G.L. BRUNO ASSOCIATES, INC.
(Metal Stud and Drywall Division)

Proposal \$131,122

Project: NPC-2 Upgrades (patch holes in ceiling subsequent to removal of surface mounted light fixtures)

PROPOSED DETAIL CHANGE.

TYPICAL CEILING REPAIR

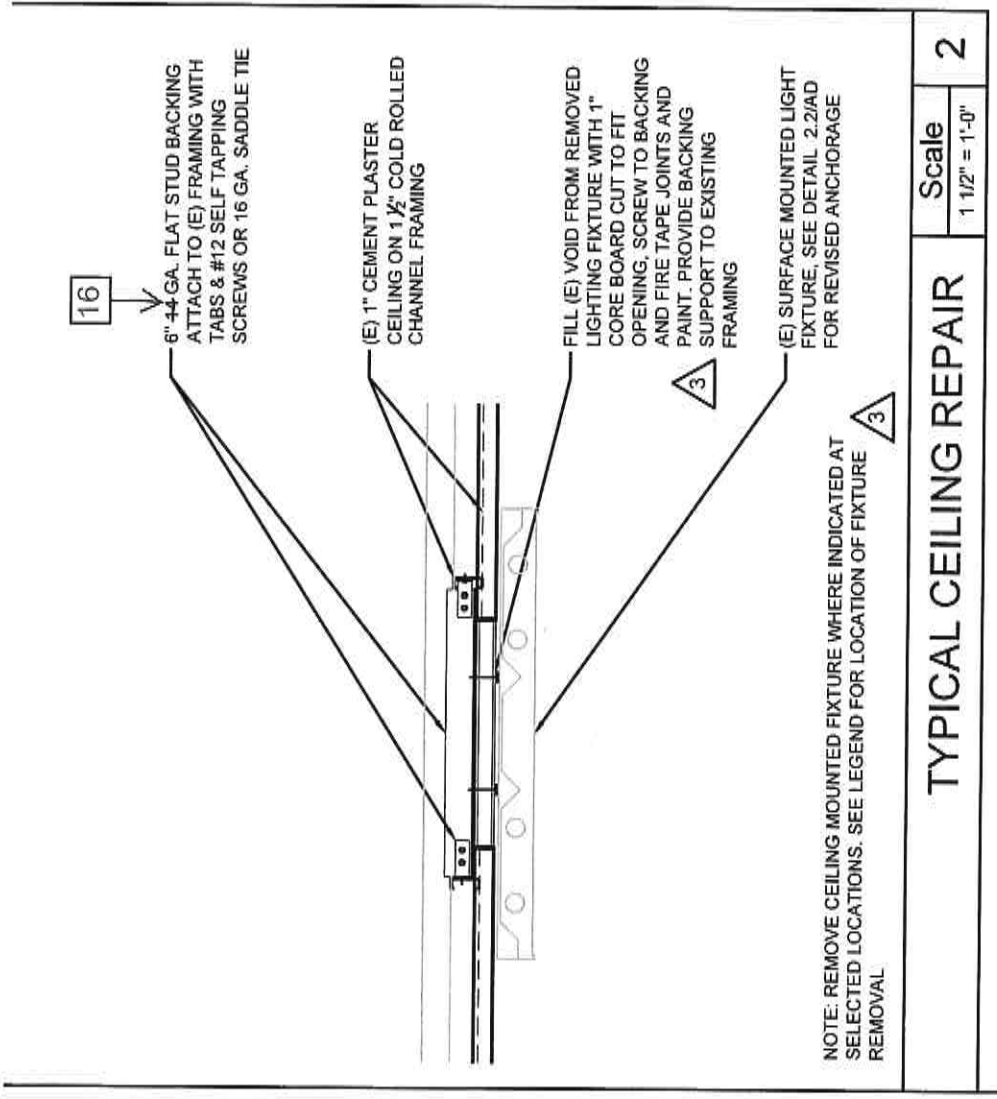
Base Bid: Furnish and install all labor & material to patch (120) holes in hospital corridor ceilings. Locations per drawings by Kluger Architects dated 8/29/19 (Delta 5, AMC 002 INTO ACD 001). Work to be performed per a modified version of detail 2/AC-1.0. Contractor proposes to use 16GA metal stud backing as opposed to 14GA.

6" 44-GA. FLAT STUD BACKING
ATTACH TO (E) FRAMING WITH
TABS & #12 SELF TAPPING
SCREWS OR 16 GA. SADDLE TIE

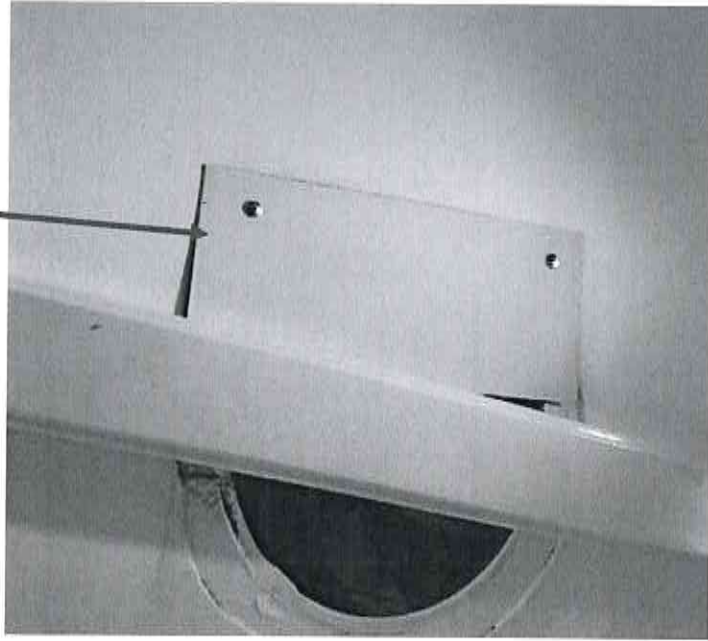
SHEET METAL PLATES COVER EXISTING HOLE
OPENING, TO BE REMOVED BY HOWE ELECTRIC.

ESTIMATED 12" X 12" METAL PLATE TO BE
DEMO'D BY GLB IN PREPARATION FOR PATCH.

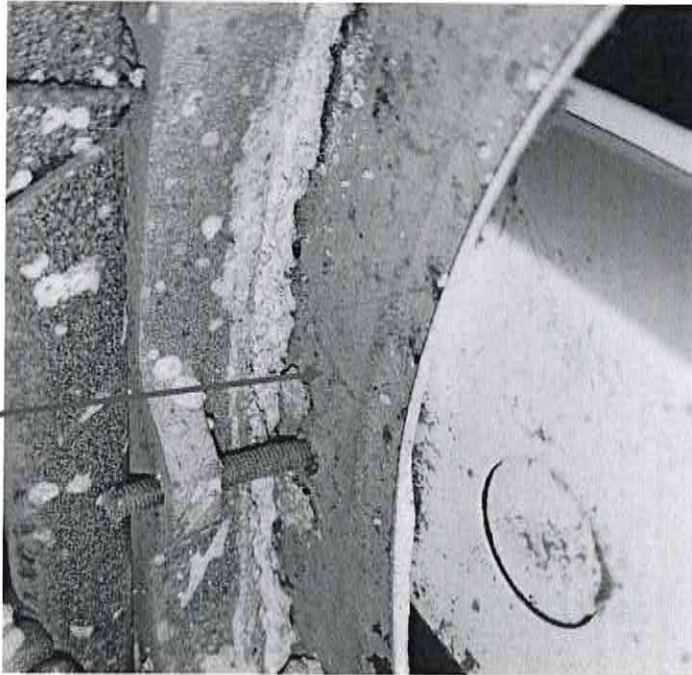
GLB TO REMOVE EXISTING +/- 12" X 12" METAL HOUSING AND WILL NEED TO "CLEAN" EDGES FOR A "SQUARE" PATCH USING 1" CORE BOARD.

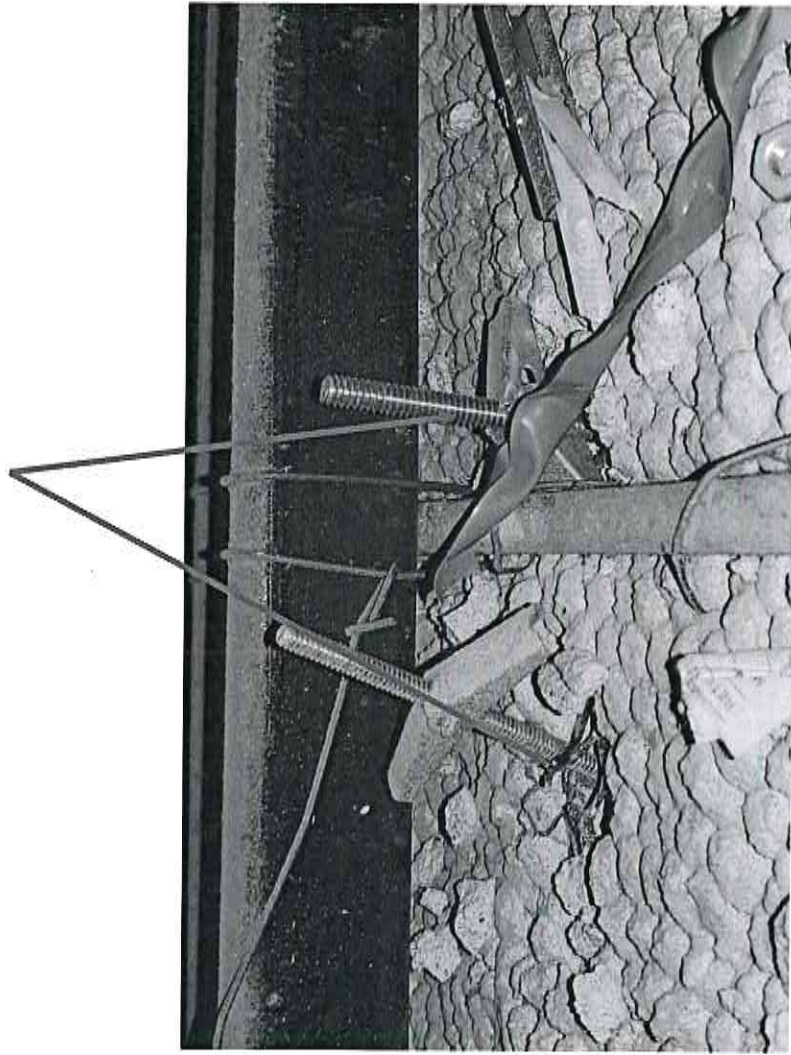
GLB TO PATCH HOLES FROM TOGGLE BOLTS THAT WILL BE REMOVED BY HOWE ELECTRIC. TO BE PATCHED WITH FS-ONE FIRESTOP.

GLB TO CLEAR AREA ABOVE NEW 6" X 16 GA METAL STUD BACKING
